L01 – Peer Review of SCA, Liverpool Boys and Girls High School (Rev 0)

13 December 2023

Environmental Peer Review and Strategic Advice – Liverpool Boys and Girls High School, Liverpool, NSW, 2170

PROPOSED LAYOUT

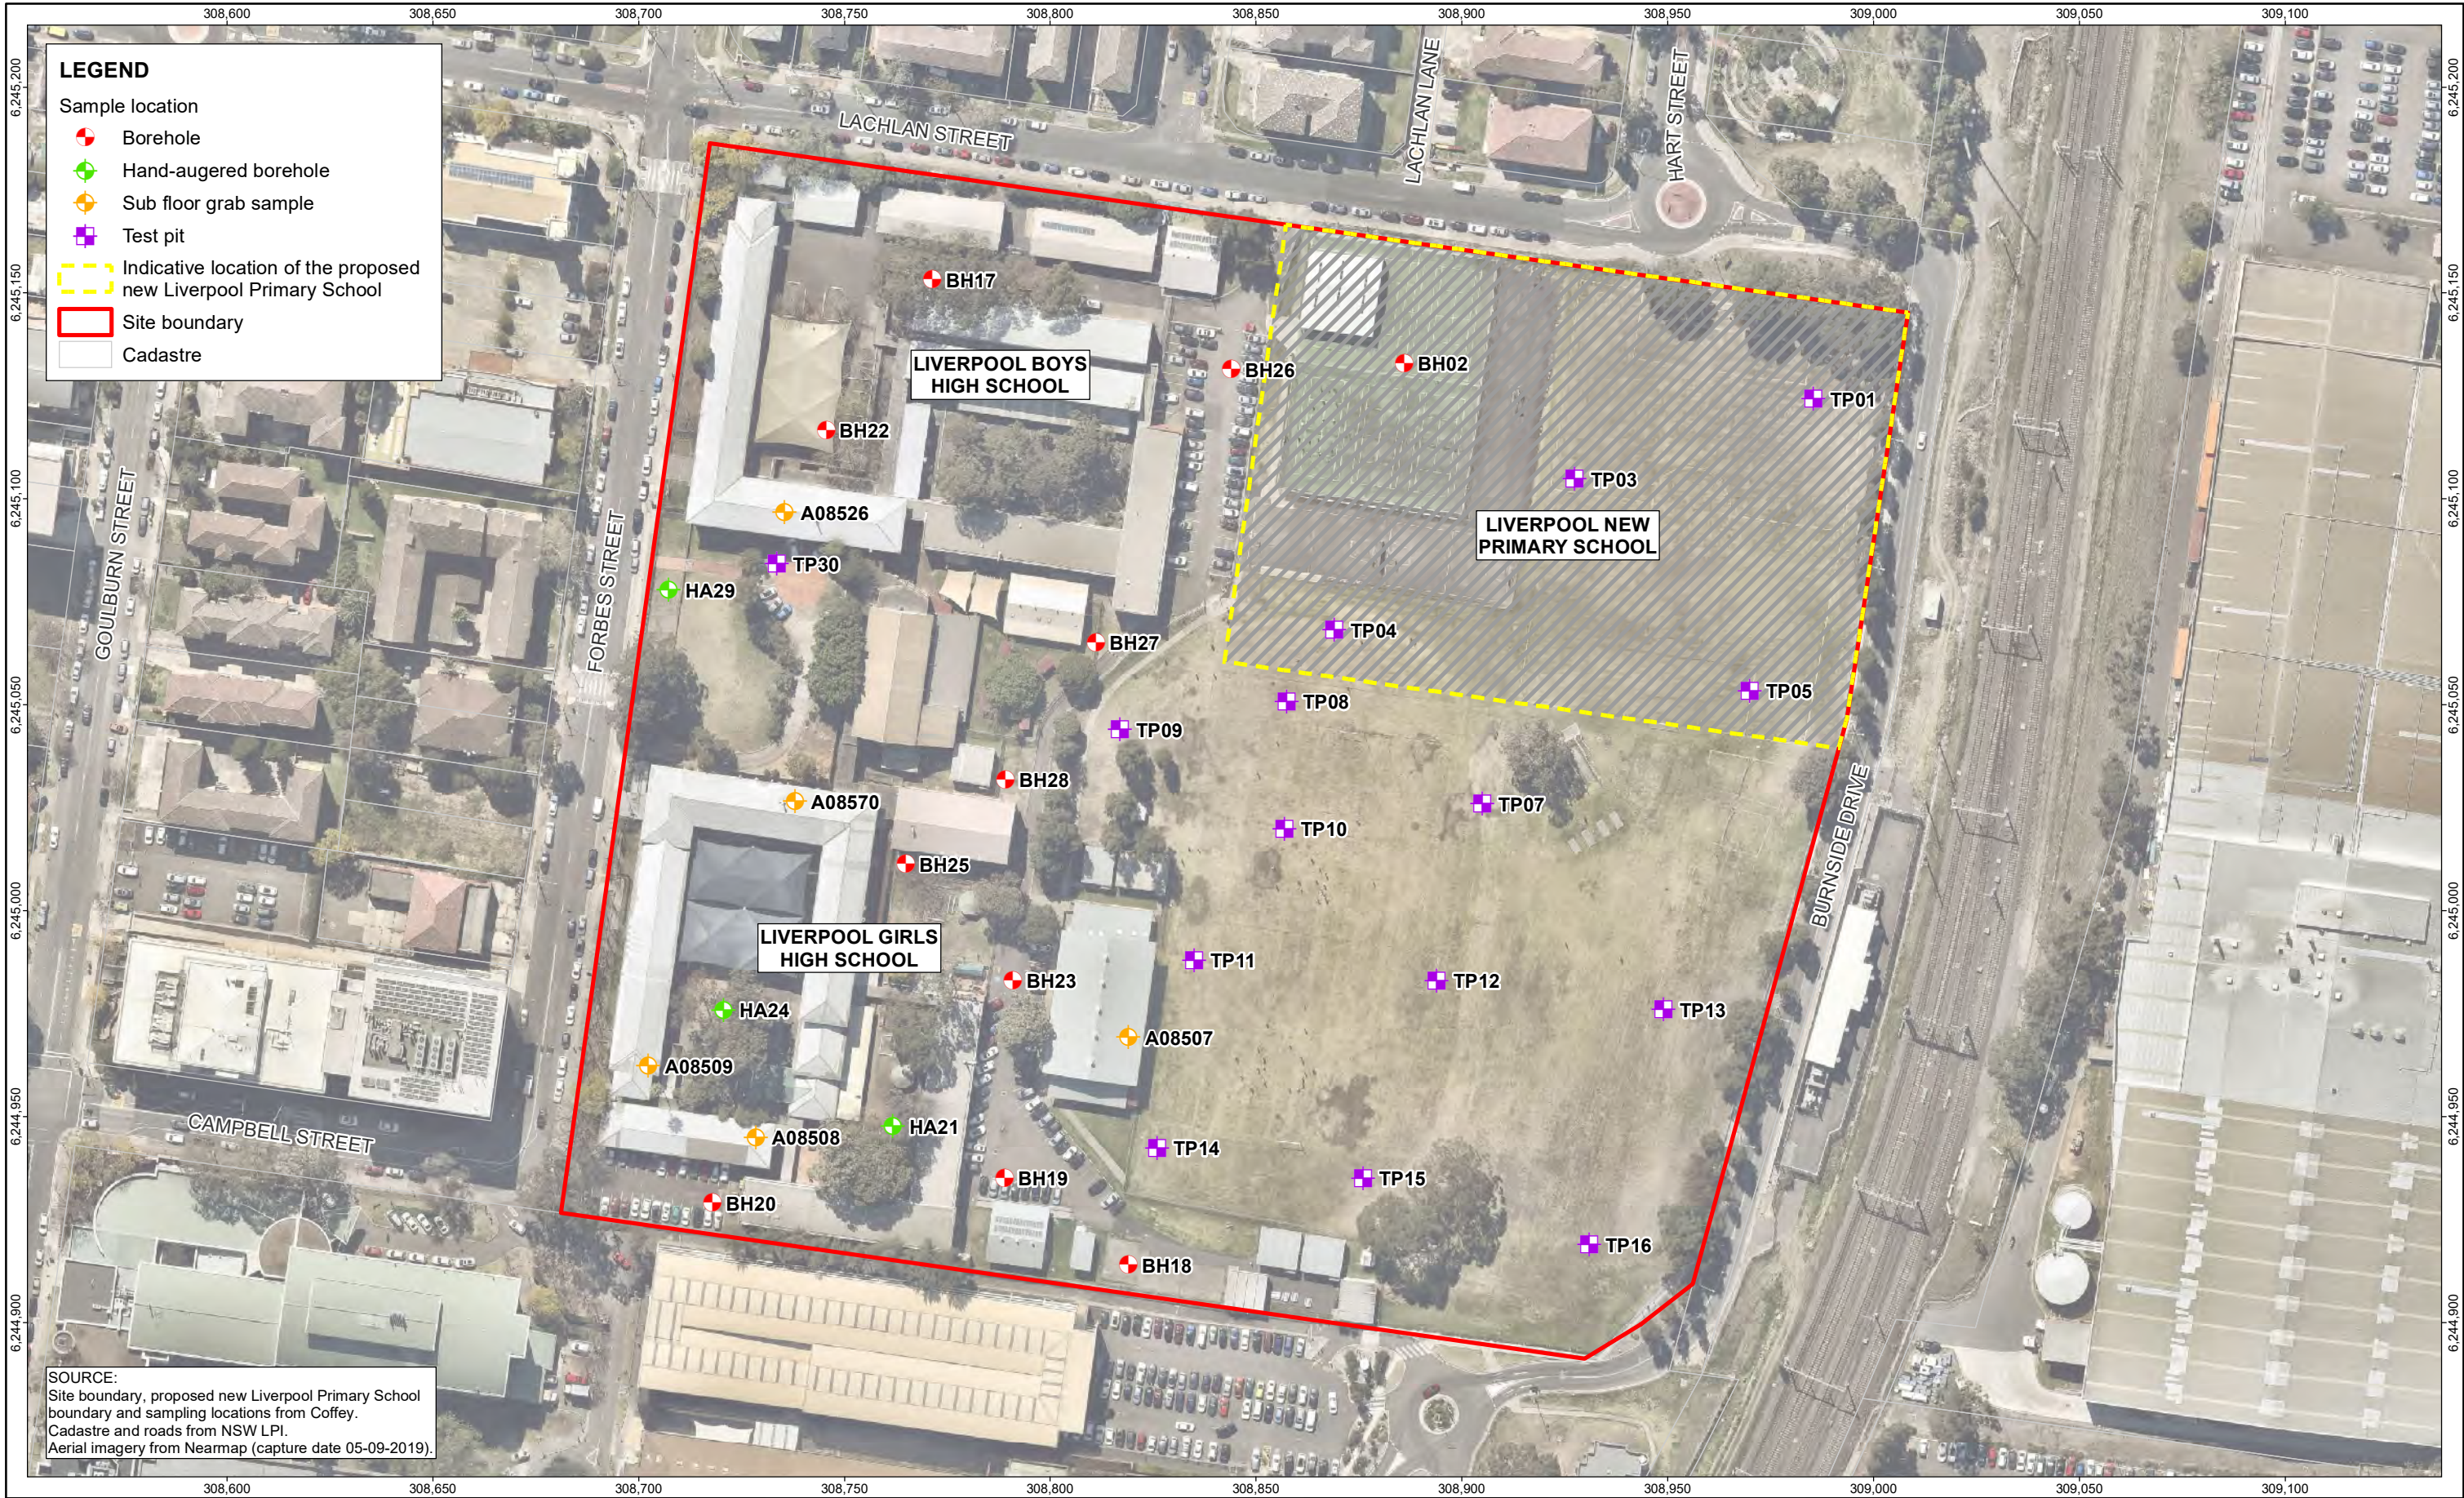
- JBS&G note that no assessment for ASS within deeper soils across the site was completed as part of the SCA.
- Douglas Partners completed a Geotechnical Investigation (DP 2019) in which P/ASS was assessed at one location, BH26, which is located within proximity to the proposed basement carpark location (central northern boundary, off Lachlan Street).

- Given the proposed underground parking facilities and the site proximity to the Georges River and disturbed terrain it is recommended that future sampling would include sampling and analysis for P/ASS within the proposed basement excavation area to confirm whether P/ASS or acidic soils are present and require management.

client: DEPARTMENT OF EDUCATION: SCHOOL INFRASTRUCTURE NSW		
project: SITE CONTAMINATION ASSESSMENT LIVERPOOL BOYS AND GIRLS HIGH SCHOOL LIVERPOOL NSW		
title: SAMPLING LOCATION PLAN		
project no:	754-SYDEN231101-R02	figure no: FIGURE 3
rev:	A

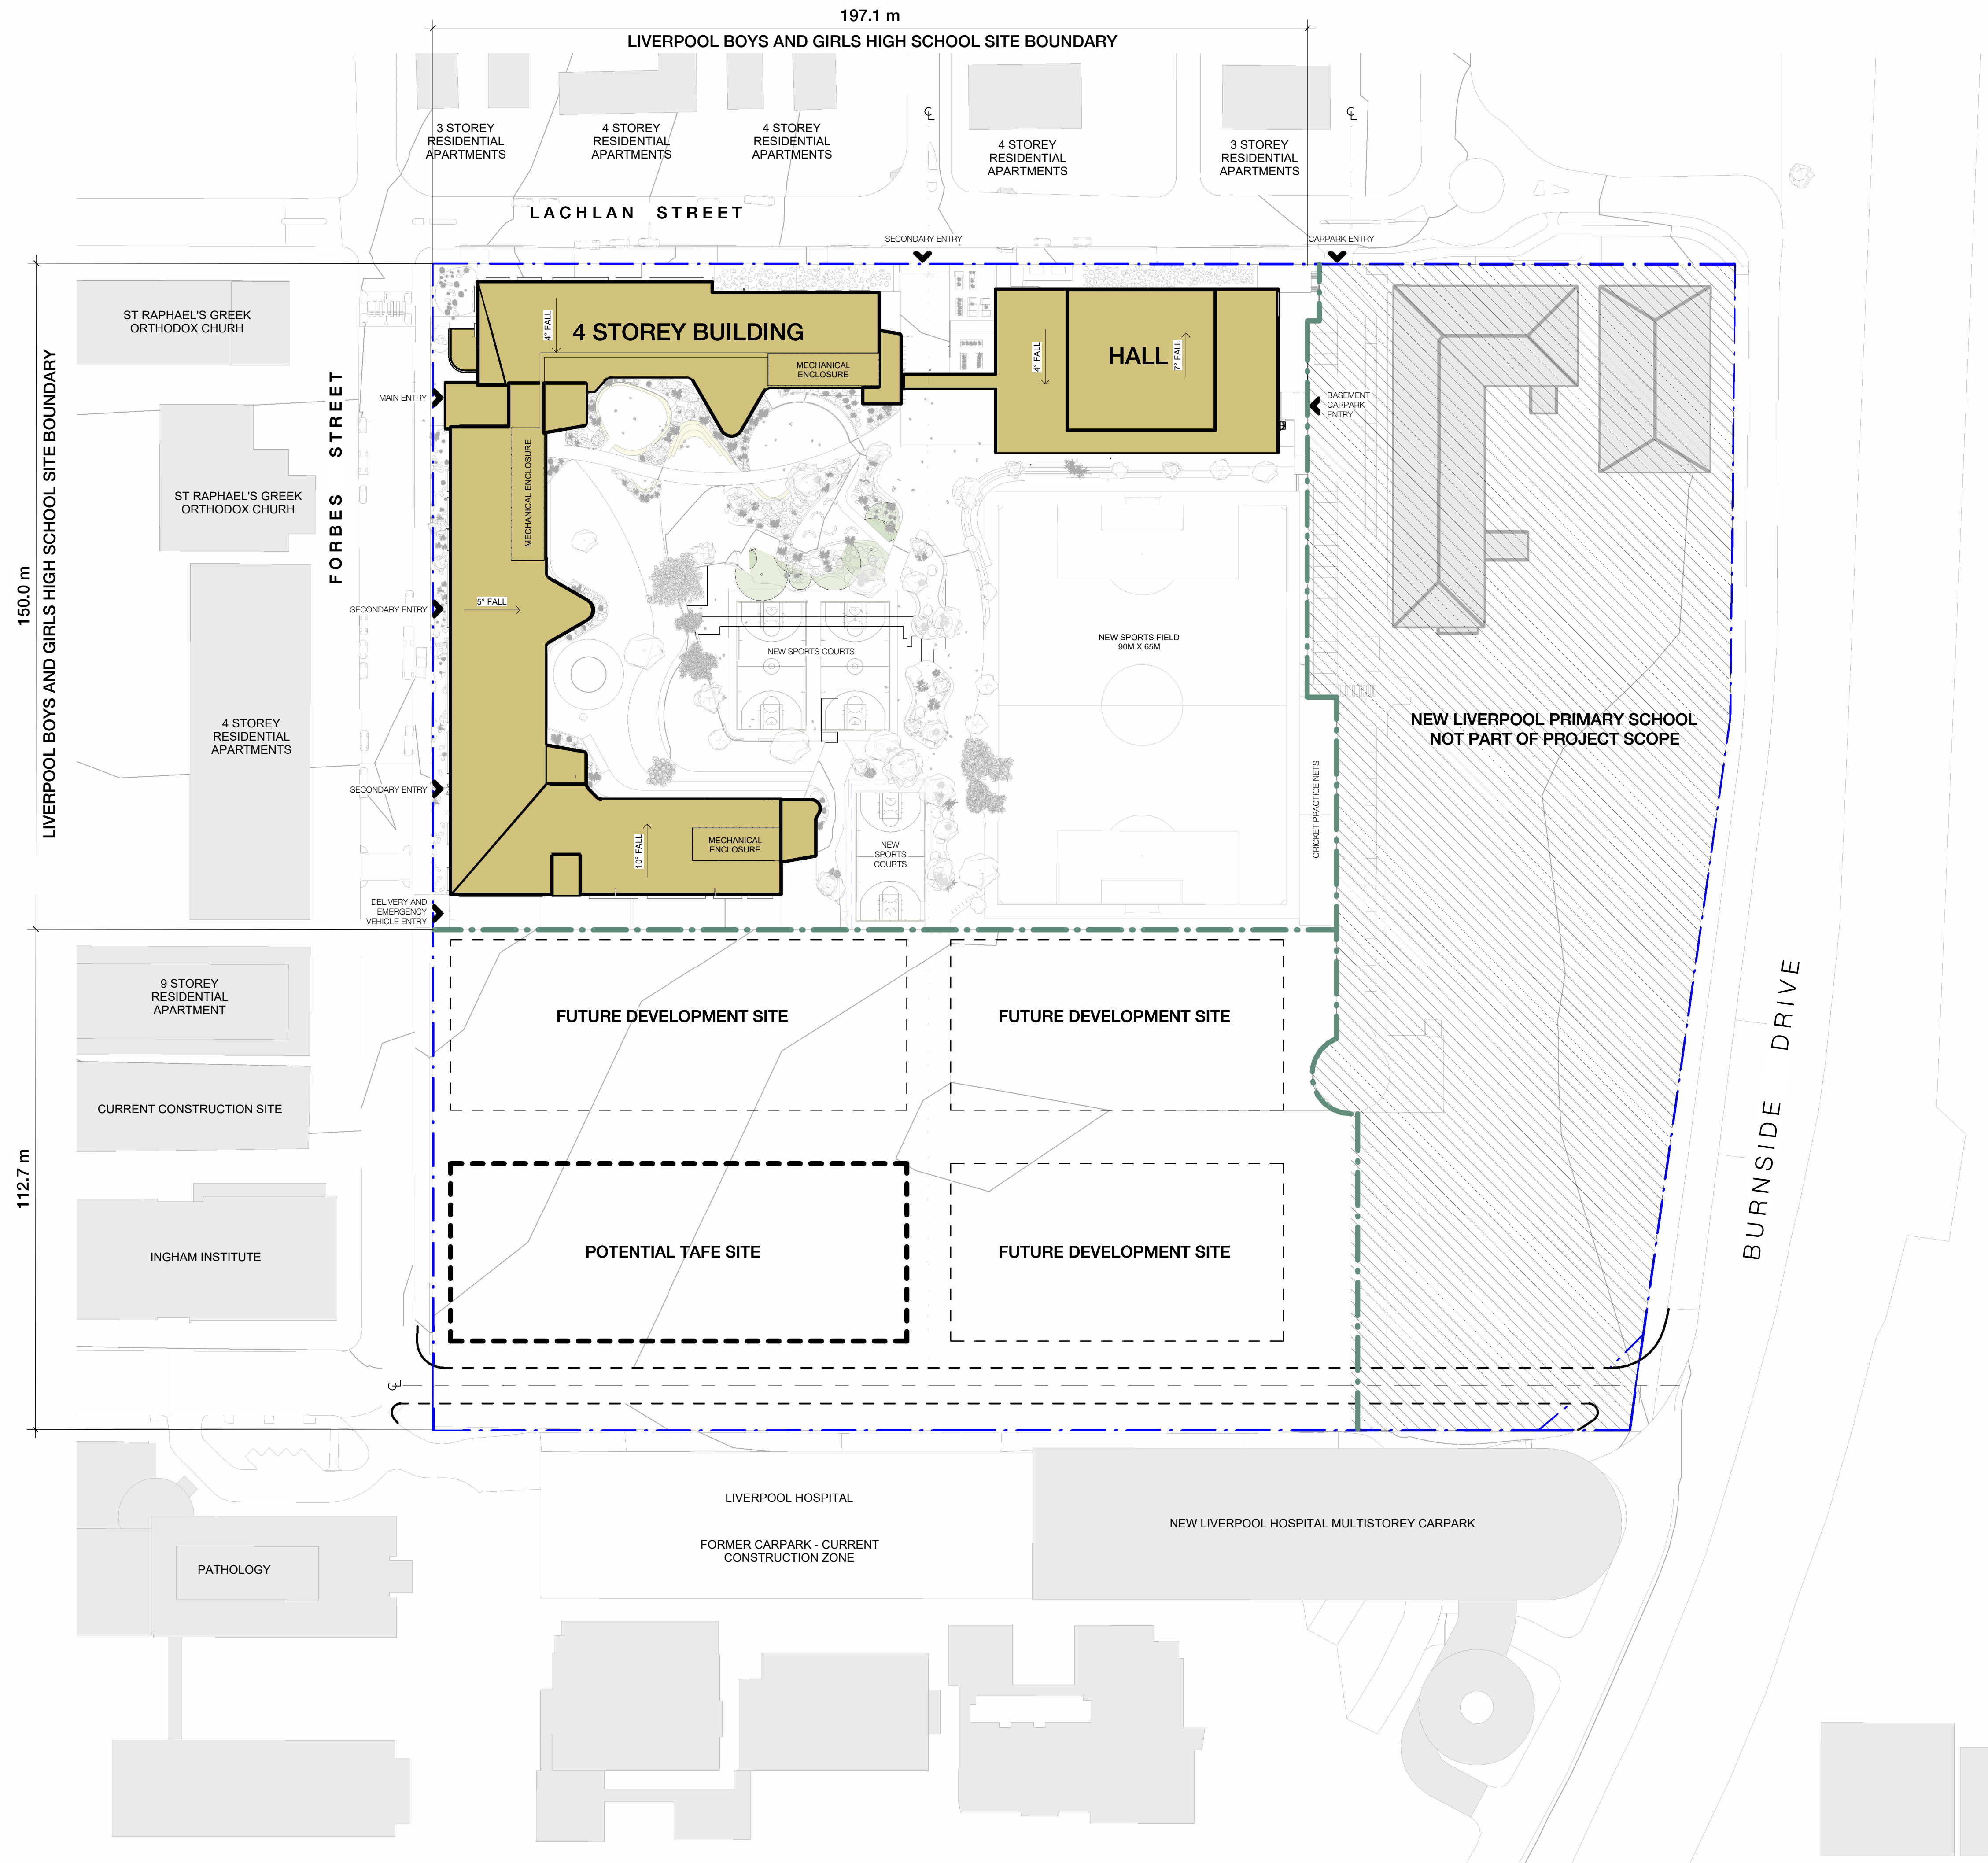
1. Further characterisation and systematic sampling to assess the extent of arsenic contamination within surface soils adjacent to sample location TP07. This will determine the level of remediation and/or management required prior to development.

2. Further characterisation and systematic sampling of the subfloor soils beneath Block A to be undertaken to further assess the potential risks to site users and contractors from asbestos. This should include sieving of soils to allow for assessment against relevant land-use NEPC (2013) criteria.

- JBS&G notes that 27 sample locations were positioned within the site (i.e. the proposed development area) which comprises an area of approximately 5.2 hectares.

- NSW EPA (2022) *Contaminated Land Guidelines: Sampling Design, Part 1 – Application*, recommends approximately 63 sample locations to adequately characterise a site of this size using a systematic sampling pattern. With consideration to the 27 sample locations advanced as part of the SCA, there is a balance of 36 sample locations. However, JBS&G notes that due to the presence of structures and associated split-level walkways/retaining walls which may impede access, advancement of an additional 36 sample locations is not likely to be feasible, and given the relatively low risk for widespread soil contamination at the site based on existing SCA data, JBS&G consider that a reduced number of samples advanced utilising a targeted sample design pattern should sufficiently characterise the site such that a remedial strategy can be developed.

- Noting the identification of friable asbestos within the subfloor area of Block A, JBS&G recommend additional sampling of subfloor soils to assess risks to future workers and inform future remedial decisions.

- It is further noted that limited test pitting has been conducted across the western portion of the site due to restricted access. This would have reduced the potential to observe anthropogenic inclusions including potential asbestos contamination within fill material, particularly in proximity to current and

historical site structures where the risk of such inclusions would be considered higher. JBS&G recommend that additional testpitting be conducted at a greater number of sample locations as part of future data gap investigation works, after which appropriate rectification works are undertaken to reinstate the surface finishes where required.

- a. **JBS&G Comment:** JBS&G agree that further assessment of the extent of arsenic contamination in soils in proximity to sample location TP07 would be required.

- a. **JBS&G Comment:** JBS&G agree that further assessment of subfloor soils beneath Block A should be undertaken. Similarly, it is agreed that further sampling methodology should allow for the assessment of results against relevant NEPC (2013) criteria as is yet to be done.
